# *Nuclear Free Local Authorities* new nuclear monitor

**Number 44, November 2016**

## **Concerns over the AP1000 Nuclear Reactor Design put forward for the Sellafield Moorside site**

**The AP1000 Chimney Effect**

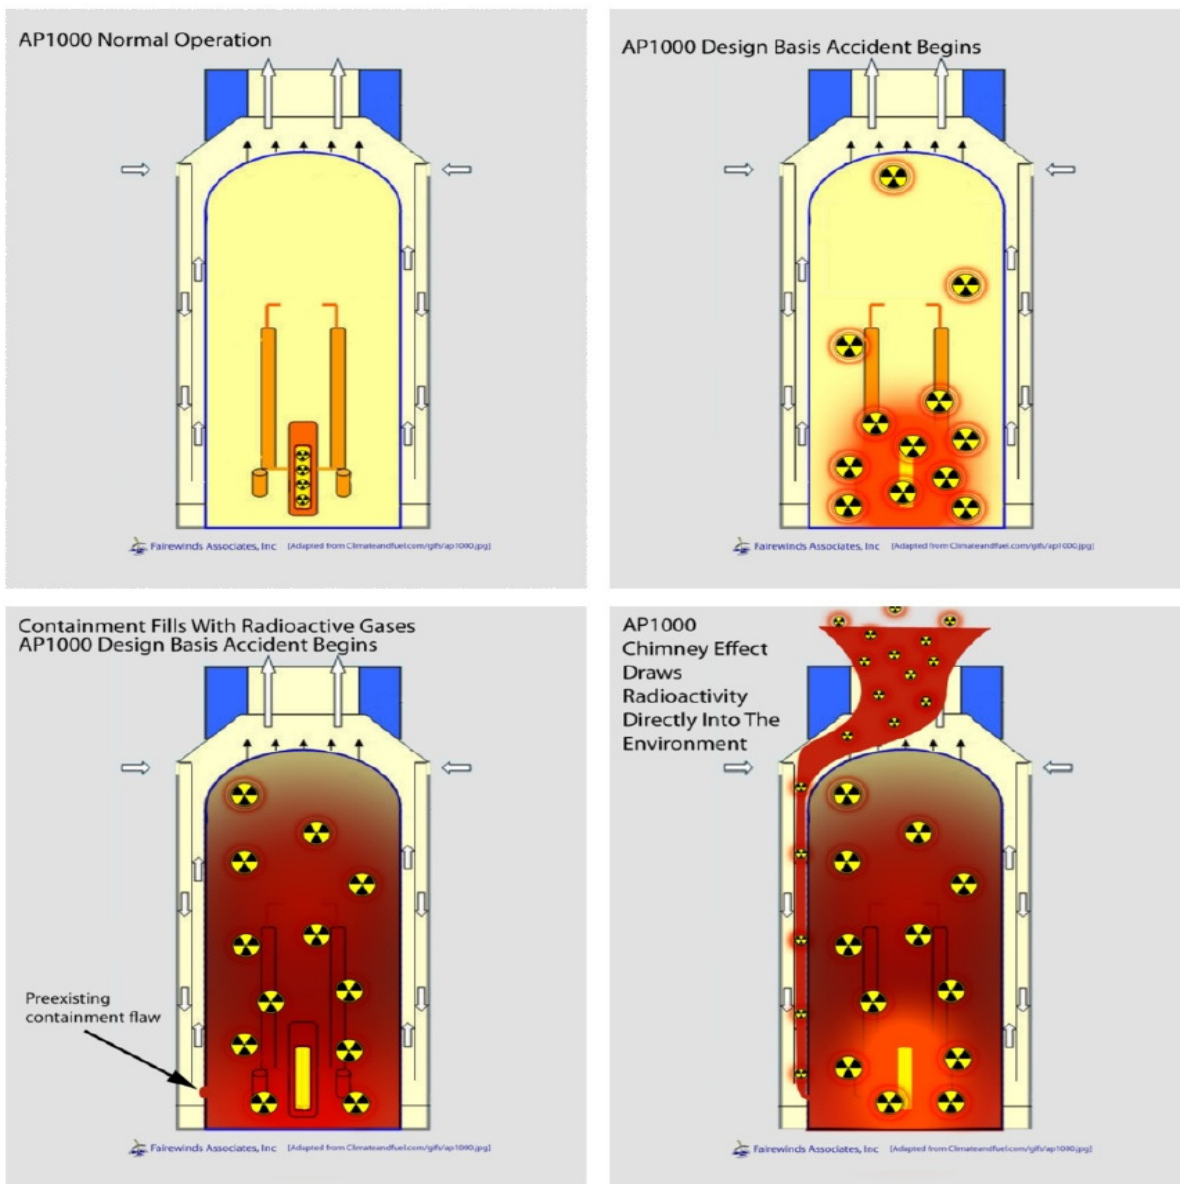
Given the history of containment failures it is reasonable to assume that a pinhole in the AP1000 containment could remain undetected. If such a pinhole were present at the start of a loss of coolant accident (LOCA) then we could see huge amounts of radiation being released due to the *chimney effect*.

Fairewinds concludes that post accident radiation doses to the public could be several orders of magnitude higher (one hundred to one thousand times higher) than those assumed by Westinghouse in its AP1000 design. This seriously impacts emergency planning over a much broader area than that presently assumed in the Westinghouse SAMDA analysis and NRC staff review.
